ADDENDUM 3

Project
Lake Forest Library Dome Roof Replacement
360 Deerpath Road, Lake Forest, IL 60045

Batten Profile
Ref. Detail 3/A501

SK-2

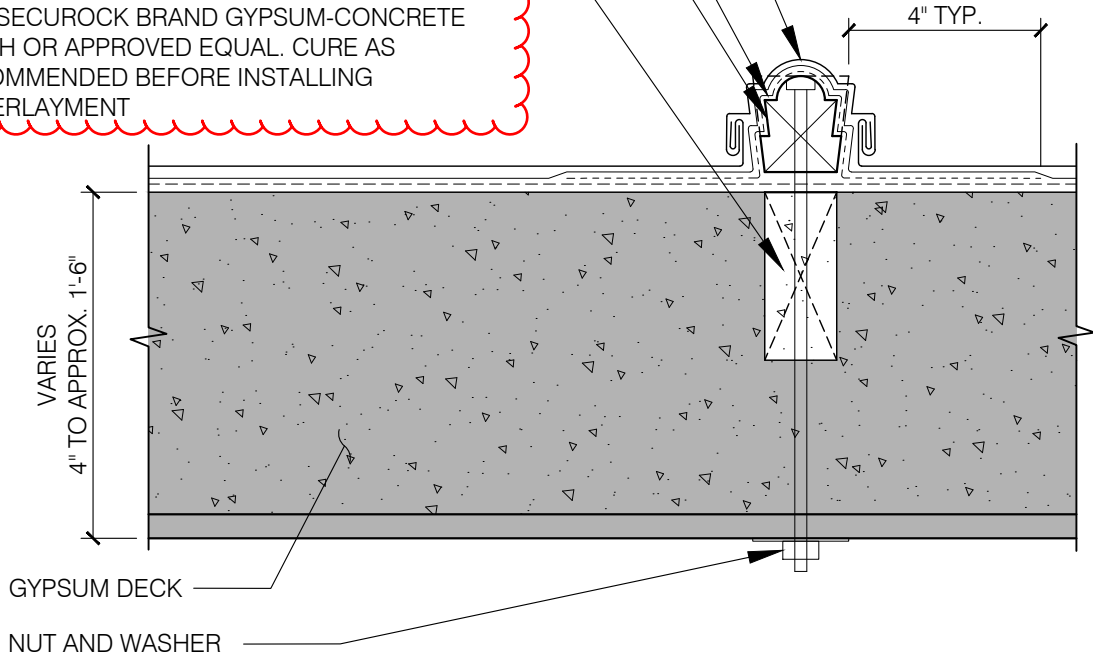
- A. Recently received information indicates that 2x4 wood blocking is embedded within the existing gypsum deck of the dome below each batten. This blocking has deteriorated and needs shall be removed as part of the project. Refer to SK-2, attached, in revision of detail 3/A501.
- B. Photographs of the dome taken in June 2017 have recently become available. The following views are provided for reference by all Bidders.

COATED COPPER BATTEN CAP.
MATCH ORIGINAL PROFILE.

SECOND PLY OF UNDERLAYMENT
WRAPPED OVER BATTEN

2x2 NON-TREATED WOOD BATTEN, TYP., MILLED
TO MATCH ORIGINAL BATTEN PROFILE AND SCORED
ON REVERSE AS NEEDED TO FIT CURVATURE OF
DOME. THRU-BOLT TO EXISTING GYPSUM DECK OR
SCREW TO EXISTING WOOD DECK.

EXISTING 2x4 BLOCKING UNDER EXISTING
BATTEN. REMOVE ALL WOOD AND FILL VOID WITH
USG SECUROCK BRAND GYPSUM-CONCRETE
PATCH OR APPROVED EQUAL. CURE AS
RECOMMENDED BEFORE INSTALLING
UNDERLAYMENT
